Contract #: 04-0120F4Cty: SF/ALA Rte: 80 PM: 13.2/13.9File #: 69.25B**QUALITY ASSURANCE -- NON-CONFORMANCE REPORT****Location:** Changxing Island, Shanghai, P.R. China**Report No:** NCR-000841**Prime Contractor:** American Bridge/Fluor Enterprises, a JV**Date:** 17-Sep-2010**Submitting Contractor:** Zhenhua Port Machinery Company, Ltd (ZPMC), Changxing Island**NCR #:** ZPMC-0803**Type of problem:**

**Bridge No:** 34-0006**Component:** East Tower Lift-5 Grillage Assembly**Reference Description:** East Lift 5 MT Missed Crack**Description of Non-Conformance:**

**Subject:** NCR No. ZPMC-0803

**Reference Description:** East Lift 5 MT Missed Crack

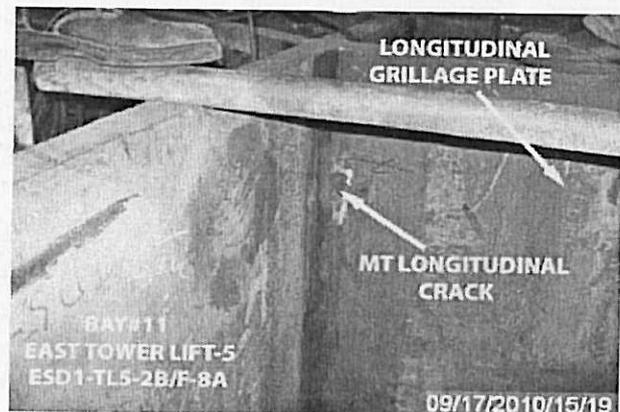
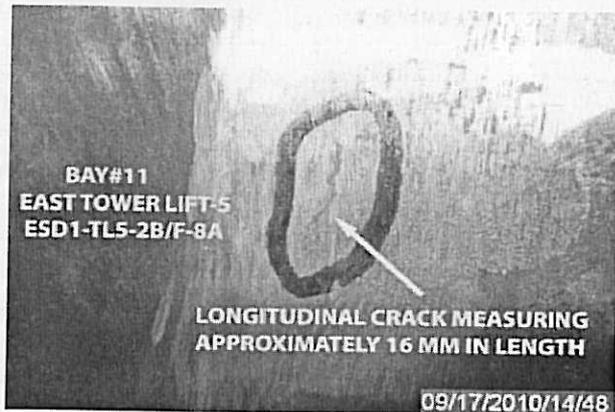
During the Quality Assurance Magnetic Particle Testing (MT) review of welds located on East Tower Lift-5, this Quality Assurance Inspector (QA) discovered the following issue:

- One (1) longitudinal crack 16mm in length found adjacent to the weld identified as ESD1-TL5-2B/F#8A.
  - The weld is a Complete Joint Penetration (CJP) T-joint, joining the longitudinal to transverse grillage plates.
  - The Y location is 310mm measured from the upper termination of the weld and is clearly marked on the material.
  - East Tower Lift-5 is located at Tower fabrication shop Bay#11.
  - The Notice of Witness Inspection Number (NWIT) is 06691.
  - This weld is within an area previously tested and accepted by ZPMC Quality Control (QC) personnel.
- ZPMC's QC personnel are required to perform 100% MT inspection of these welds.
- For further information, please see the attached pictures below.

ZPMC received NCR-000841(ZPMC-0803), it mentioned that CT inspectors found indication on base metal adjacent to the weld ESD1-TL5-2B/F-8A.

Once CT inspector found indication on metal adjacent to the weld, ZPMC performed grinding work under approval of CT site inspector. Finally the indication was removed and the area was tested and accepted by using MT manner.

项目名称 Project Name	美国海湾大桥 SFOBB	部件图号 Drawing No	FASA5-2	报告编号 Report No.	T-WR3546
合同号 Contract No.:	04-0120F4	部件名称 Items Name	东塔五吊A面板 Tower(E) 5 <sup>th</sup> 1 ifting Skin A	NDT报告编号 Report No.of NDT	NA
项目编号 Project No.:	ZP06-787

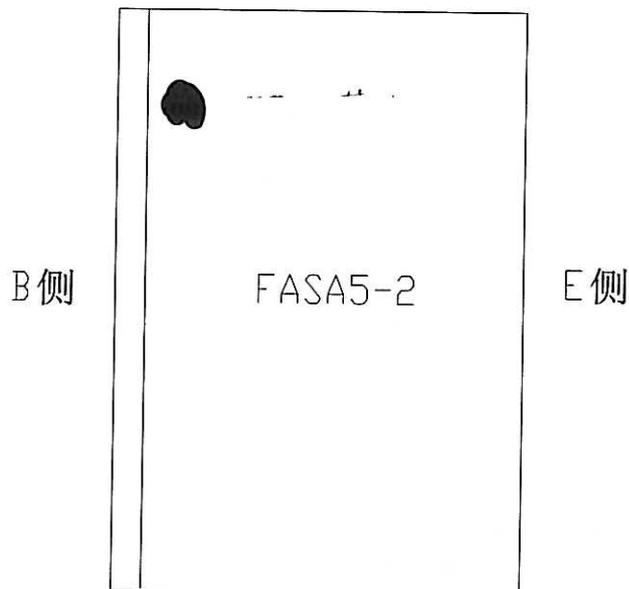
东塔第五吊装段A面板FASA5-2, 母材打磨过度, 最深达3MM, 现需要补焊, 具体位置见下图  
 East tower 5<sup>th</sup> lifting Skin A FASA5-2, the base metal was gouged after grinding, maximum 3mm in depth and needed to repair, the detail position sees the following draft.

Worker operator error caused base metal gouged.

1. Grind the repair area to a smooth finish according to the approved repair WPS.
2. Prepare the joint according to the approved WPS.
3. Perform 100%MT and 100%VT of the repair area.
4. Remove all defects by grinding to ensure all defects are completely removed if defects still exist, and repeat "step 4" to assure complete removal of all defects if necessary.
5. Clean the repair area of all loose debris including MT powder.
6. Preheat and weld according to the approved WPS.
7. Grind the weld flush after welding.
8. Perform NDT of the repair area.
